REVISED AGENDA

Board of Public Works Meeting
Tuesday, July 26, 2016 – 7:00 P.M.
Jackson Village Hall
N168W20733 Main Street

**STONEWALL CONNECTION SIDEWALK
 RIDGEWAY RD TO EAGLE DR
 VILLAGE OF JACKSON**

FINISHED TYPICAL SECTION
STONEWALL CONNECTION TRAIL

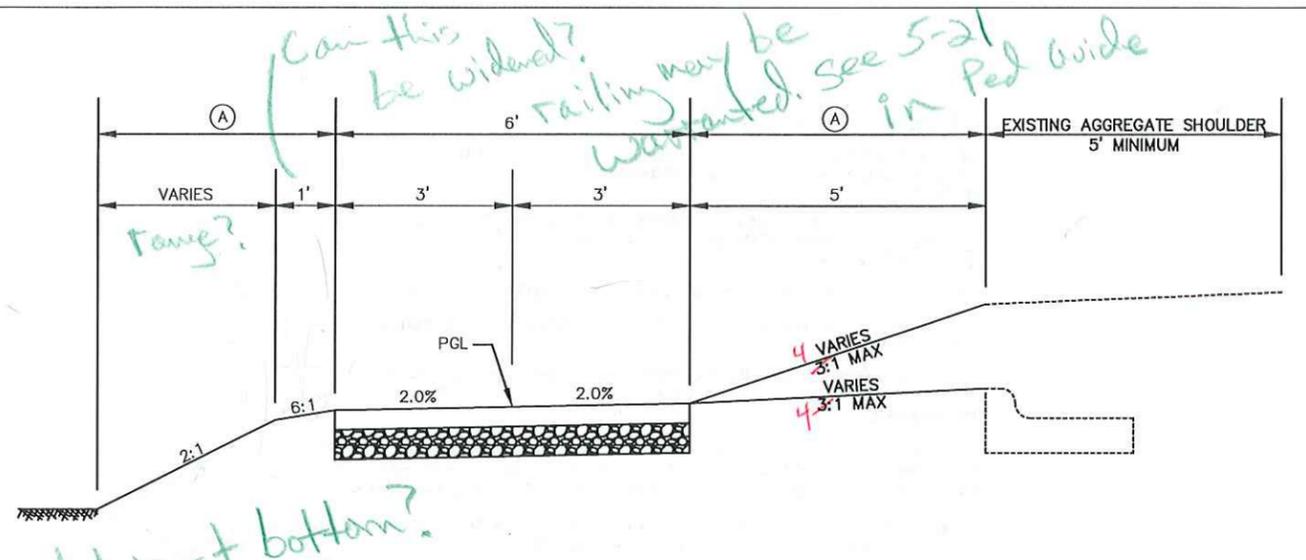
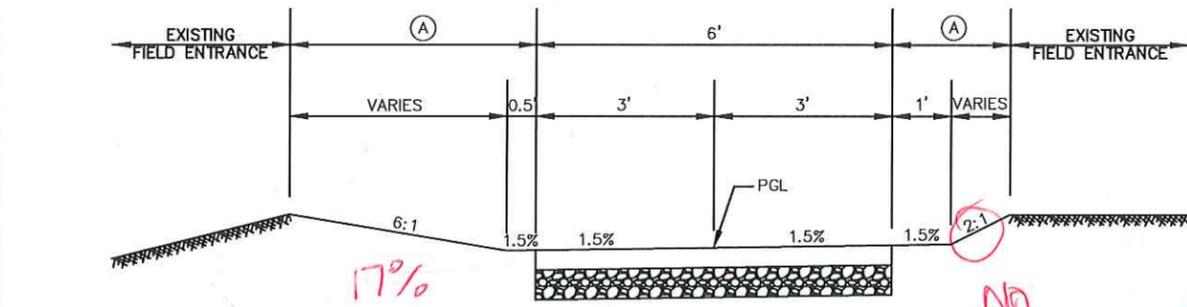
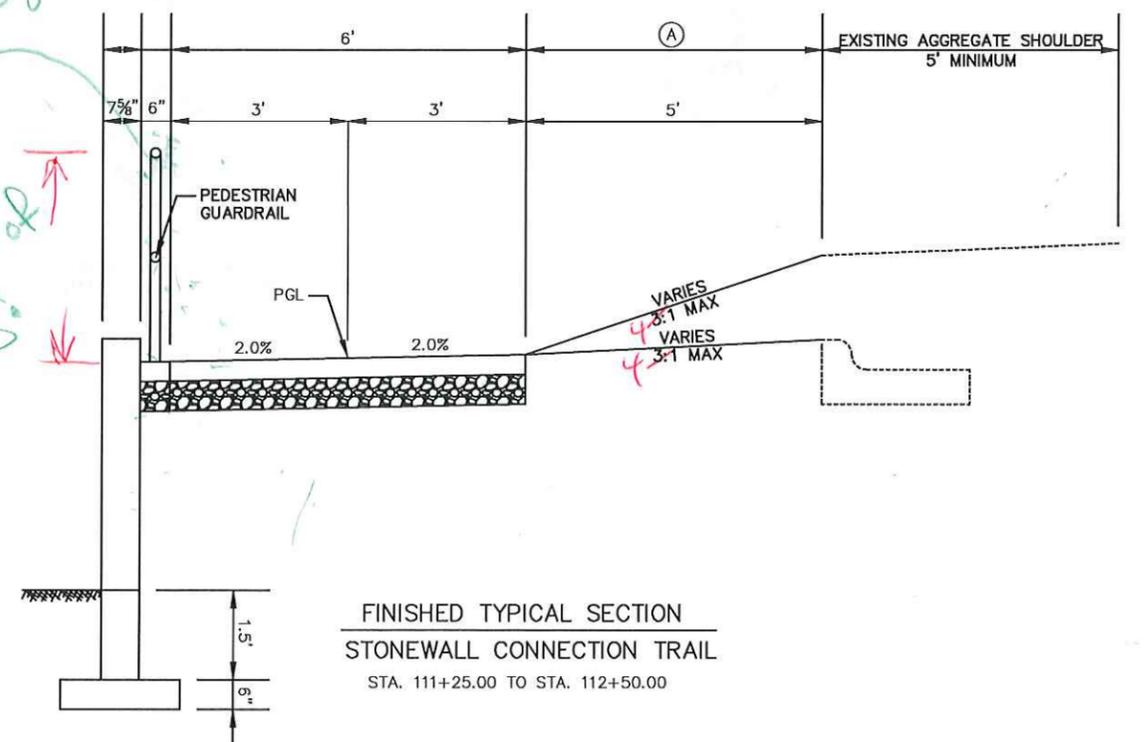
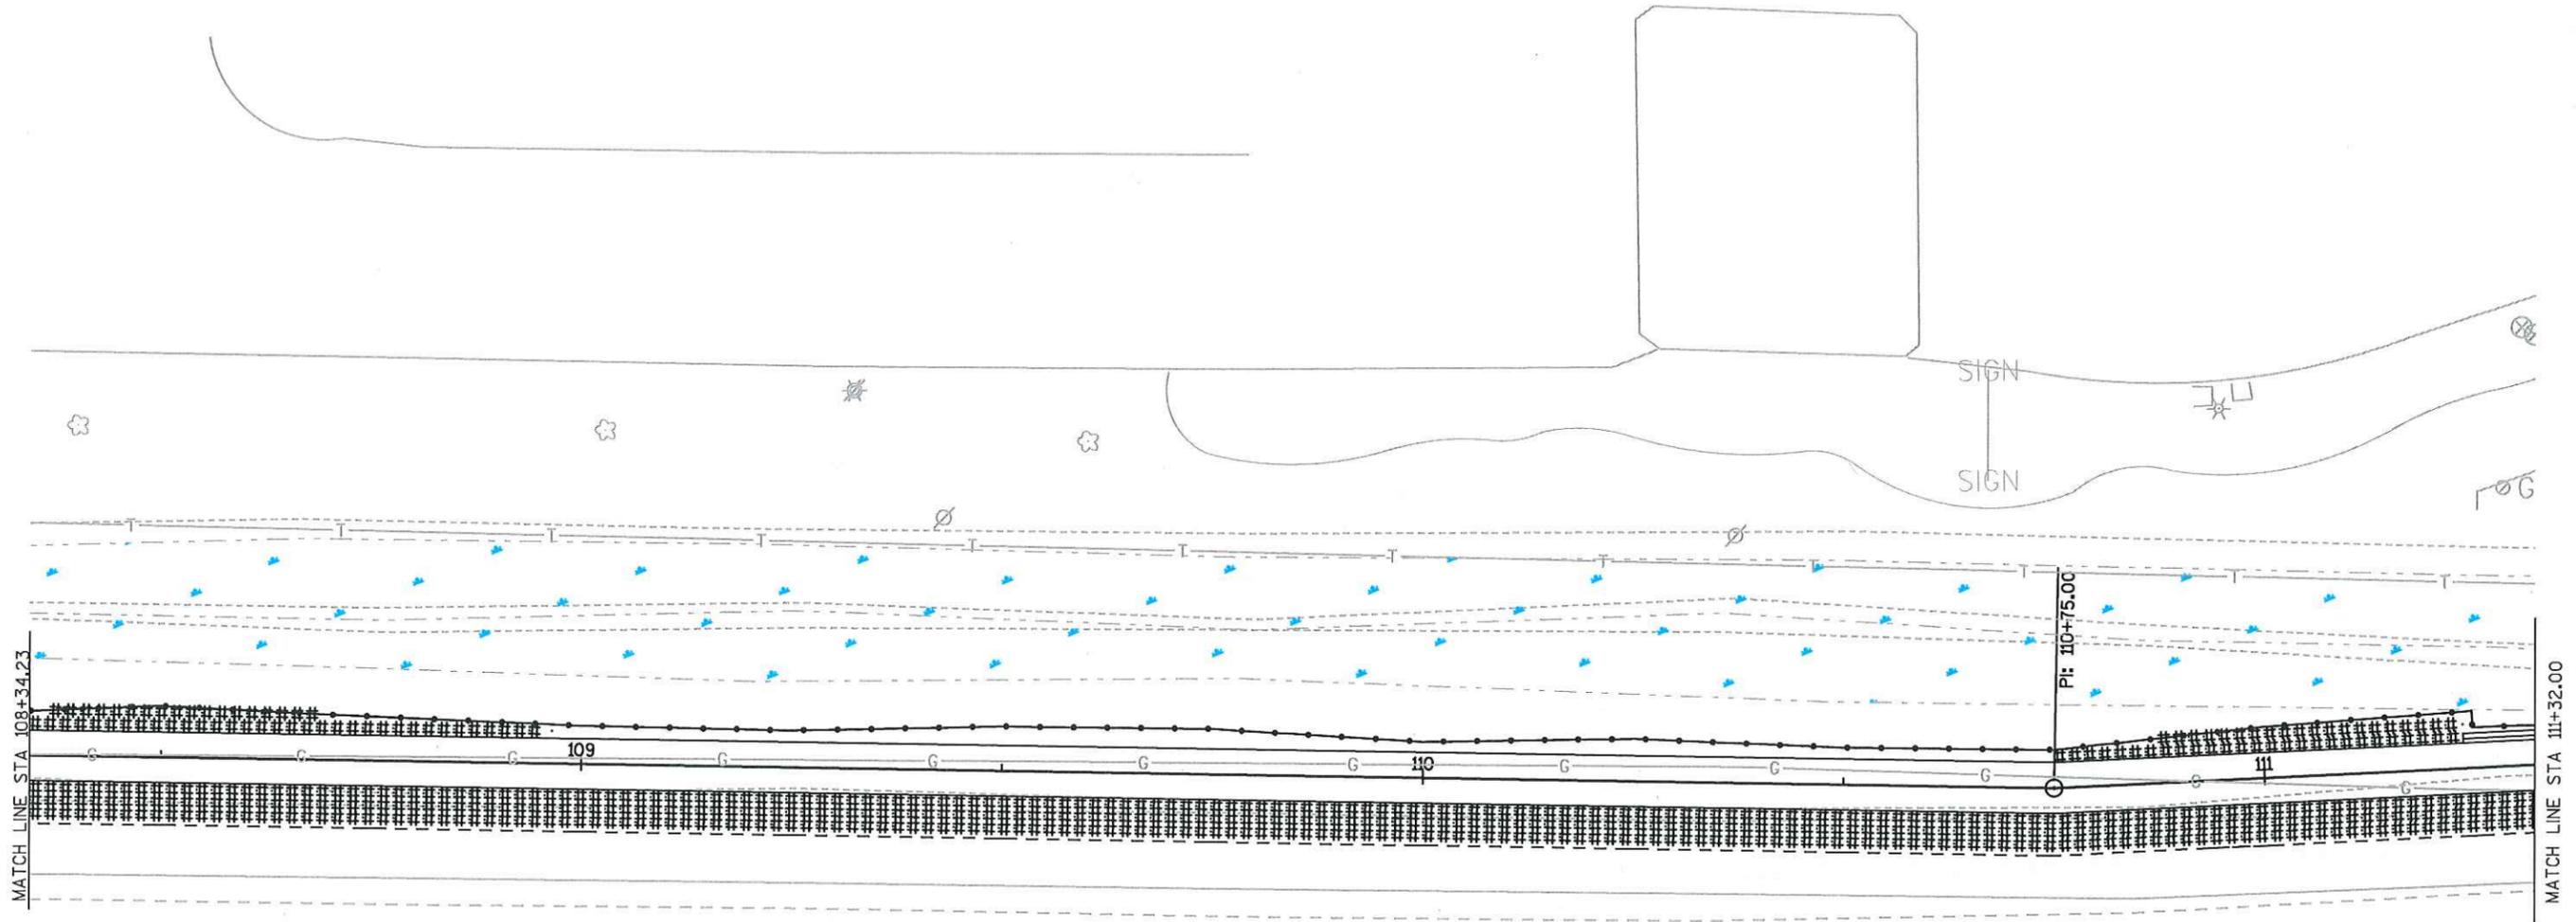
- Sheet 5:
 - Upper Right Typical:
 - Provide a range for the downslope on the left slide instead of just "varies".
 - There appears to be a section of sidewalk adjacent to a 2:1 slope, with a drop-off of around 5' or more and water at the bottom. Given these conditions a fence or railing should be considered. Alternatively, can the 1' shoulder be widened to provide greater separation from the drop-off? See Section 5.3.1.2.6 of the WI Guide to Pedestrian Best Practices for a list of considerations. What is the maximum vertical drop adjacent to the sidewalk?

- Lower Right Typical: Identify railing height. Outside railings should be a minimum of 42" in height.
- Sheet 15: See previous comments in my 7/1/16 email regarding the need for construction details for curb ramps. How will the curb ramps be aligned for the NE quadrant of the Ridgeway intersection so that pedestrians do not have to traverse non-compliant cross-slopes and ramp flares? The plan appears to show the detectable warning fields (DWFs) and ramp flares (?) within the walking area for a pedestrian approaching from the north and wishing to go east along STH 60.

Use approved list of railing

height of railing

Typical Sections Upper Right	Right side slope should not exceed 4:1	Profile altered to make right side slope not exceed 4:1.	
	Typical Sections Lower Right	Use approved list of railings. Show height of railing.	Railing is 42 inches.	
	Typical Sections Lower Right	Right side slope should not exceed 4:1	Profile altered to make right side slope not exceed 4:1.

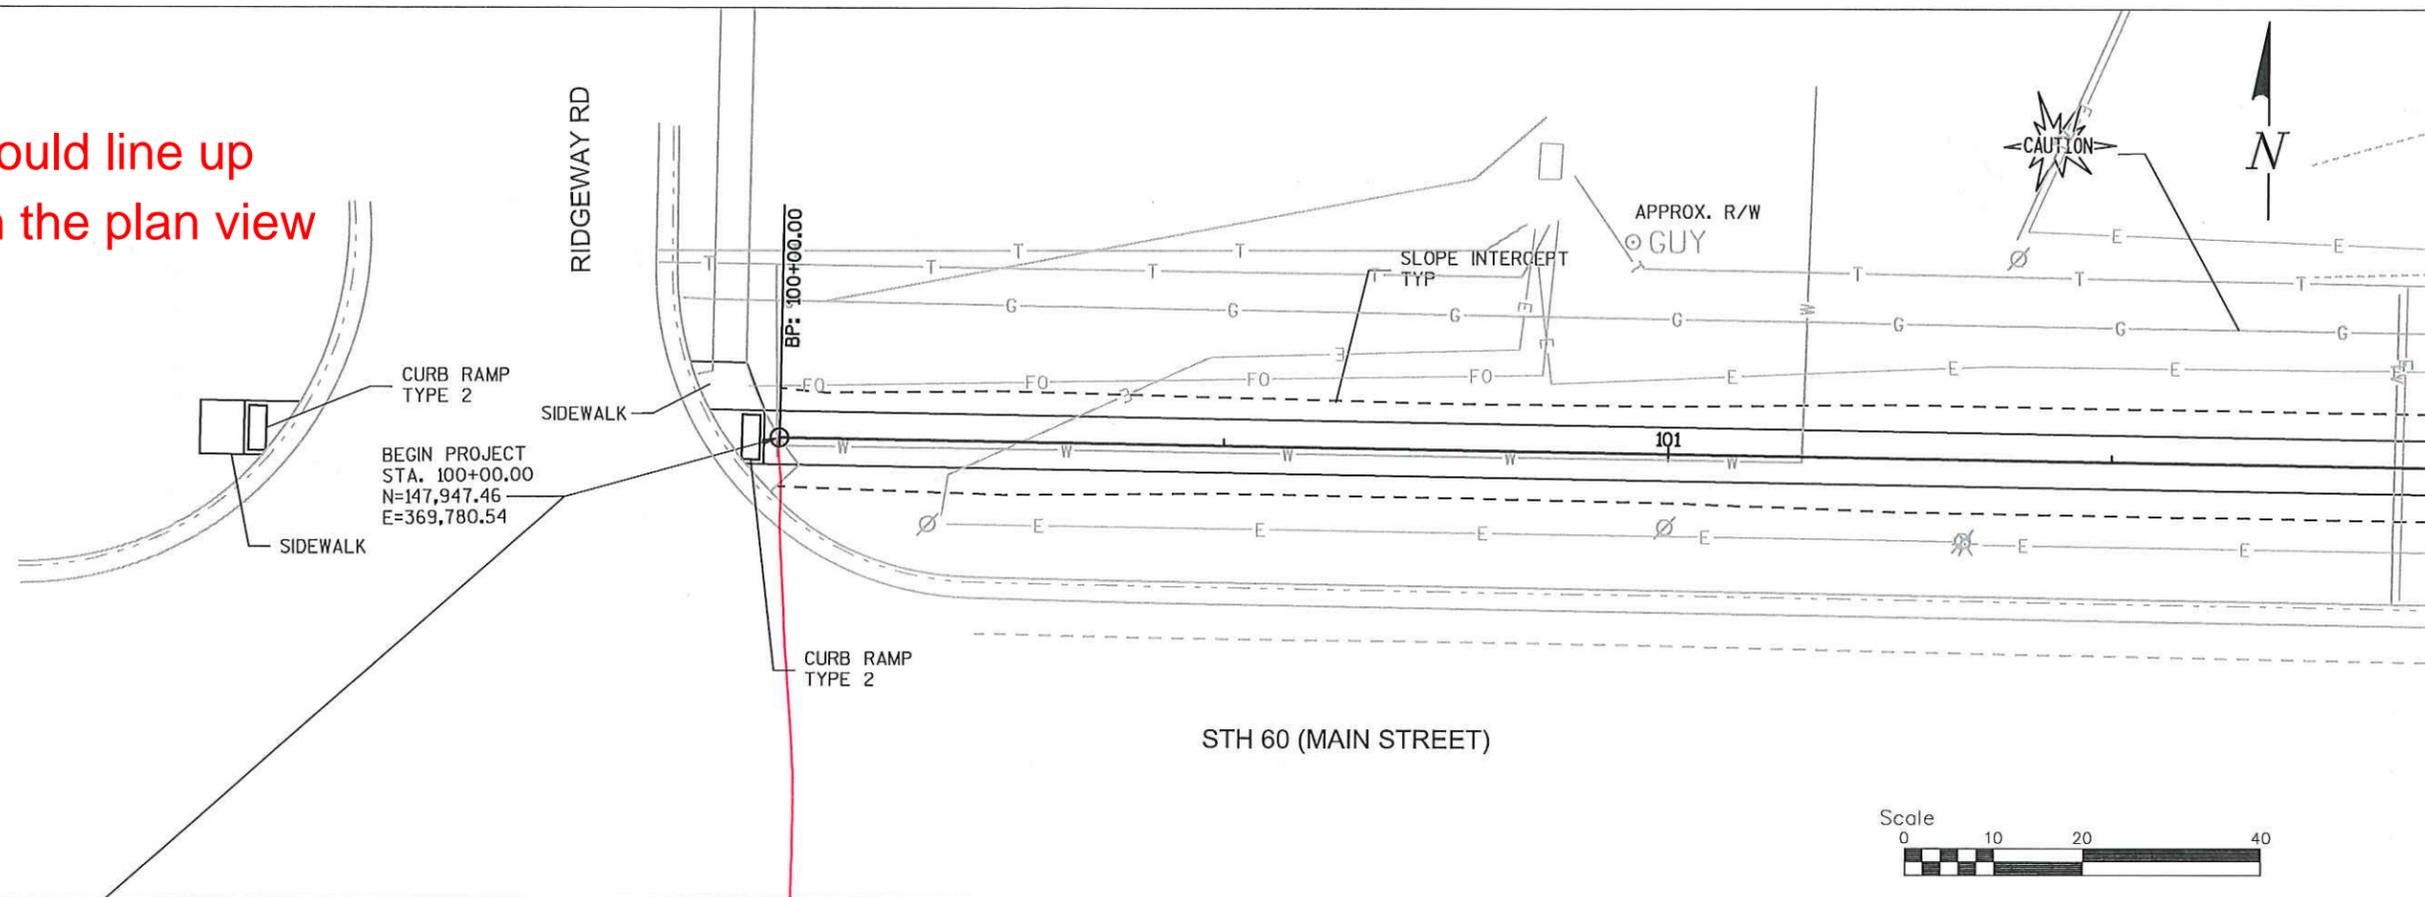
the profile should line up vertically with the plan view

Sheet 11	Plan & Profile	Line up plan and profile vertically	Yes.	
Sheet 17	Plan & Profile	Reditch to not trap water from flume		
Sheet 17	Plan & Profile	Raise profile over field entrance.	Profile raised to reduce side slopes. Maximum slope now 9.3%.	
	Cross Sections	Scale	Yes.

FINISHED TYPICAL SECTION
 STONEWALL CONNECTION TRAIL
 STA. 100+00.00 TO STA. 105+25.00

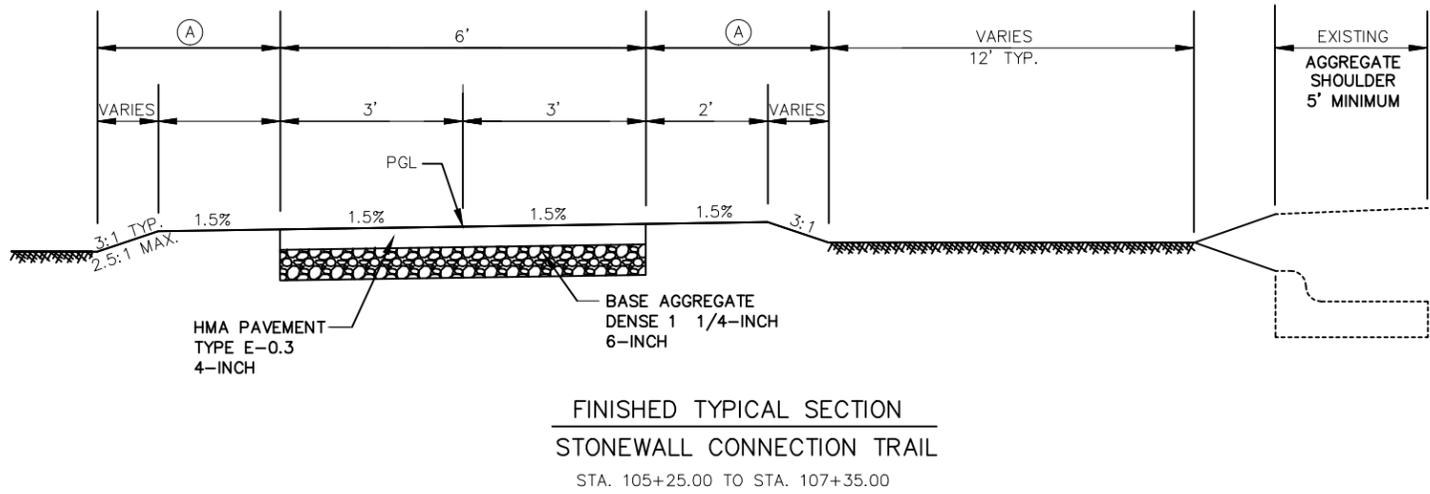
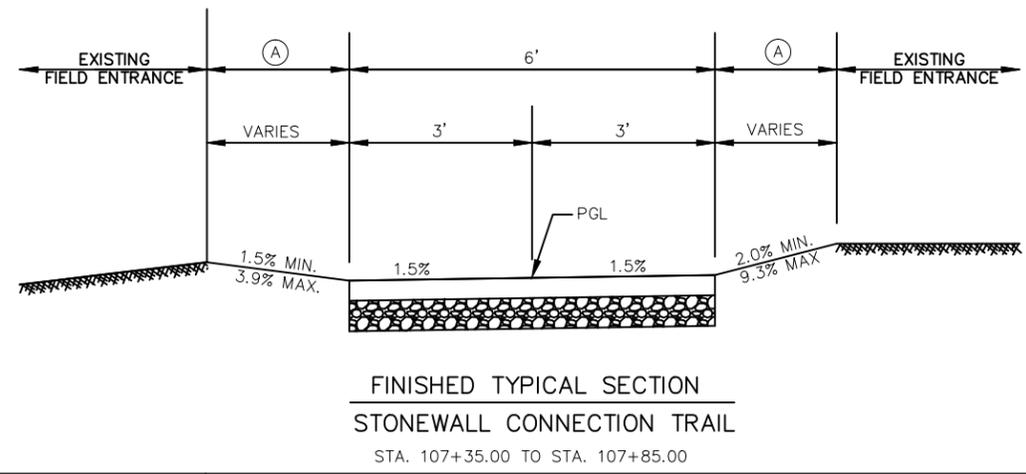
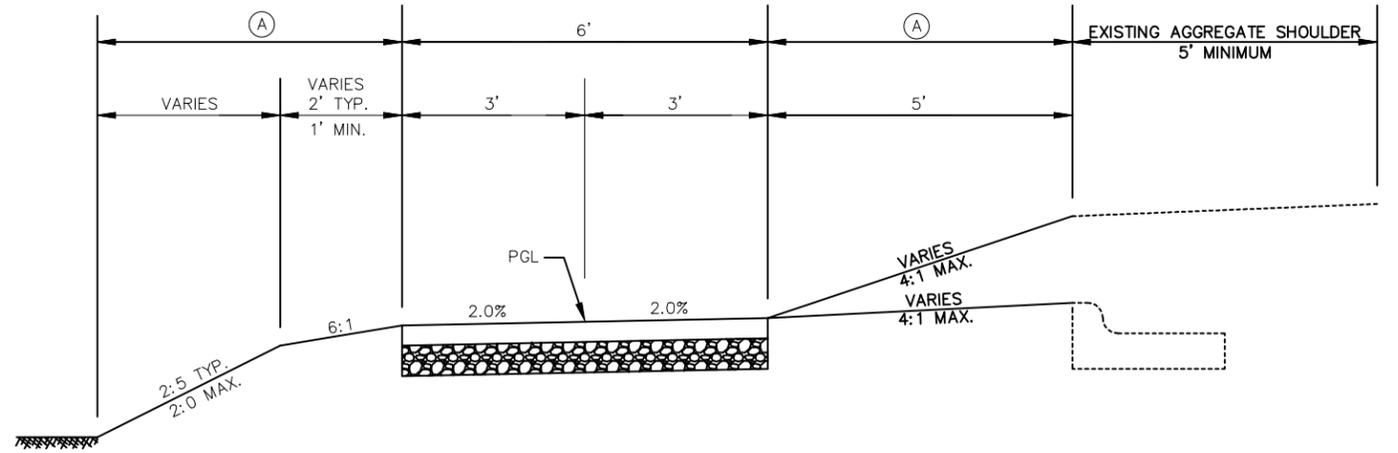
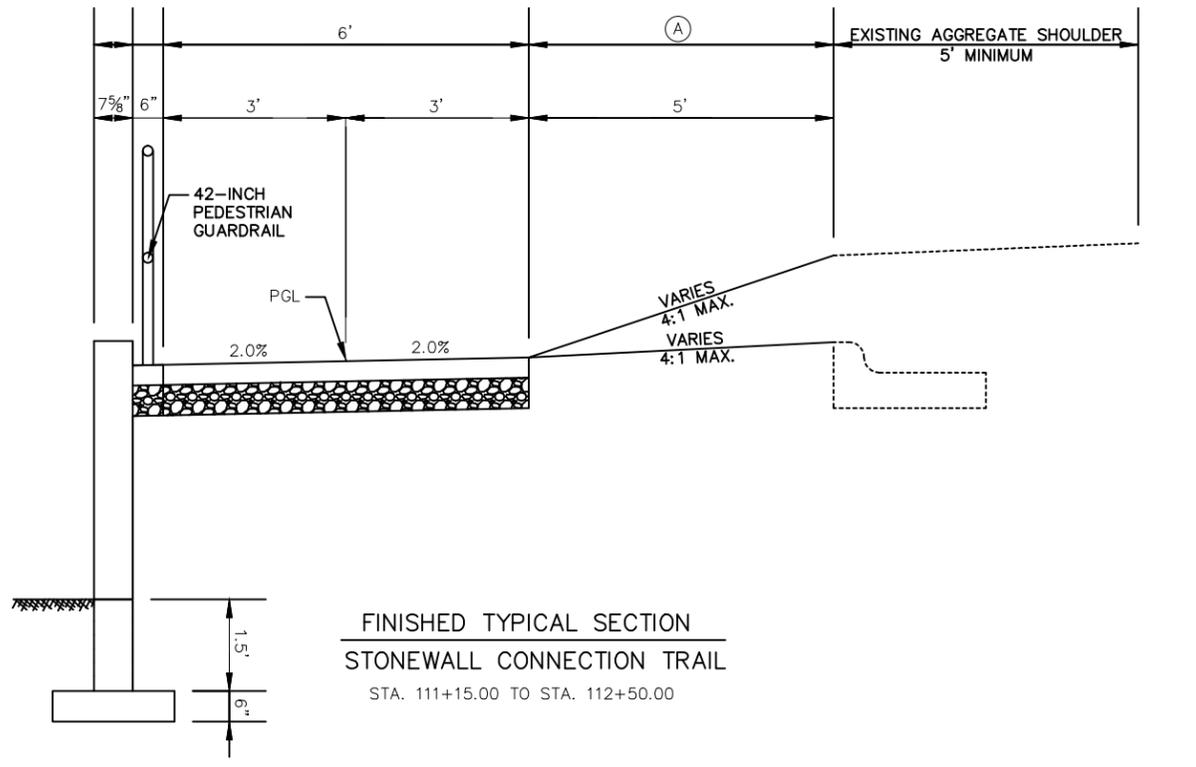
- Sheet 5:
 - Upper Right Typical:
 - Provide a range for the downslope on the left slide instead of just "varies".
 - There appears to be a section of sidewalk adjacent to a 2:1 slope, with a drop-off of around 5' or more and water at the bottom. Given these conditions a fence or railing should be considered. Alternatively, can the 1' shoulder be widened to provide greater separation from the drop-off? See Section 5.3.1.2.6 of the WI Guide to Pedestrian Best Practices for a list of considerations. What is the maximum vertical drop adjacent to the sidewalk?

- Lower Right Typical: Identify railing height. Outside railings should be a minimum of 42" in height.
- Sheet 15: See previous comments in my 7/1/16 email regarding the need for construction details for curb ramps. How will the curb ramps be aligned for the NE quadrant of the Ridgeway intersection so that pedestrians do not have to traverse non-compliant cross-slopes and ramp flares? The plan appears to show the detectable warning fields (DWFs) and ramp flares (?) within the walking area for a pedestrian approaching from the north and wishing to go east along STH 60.
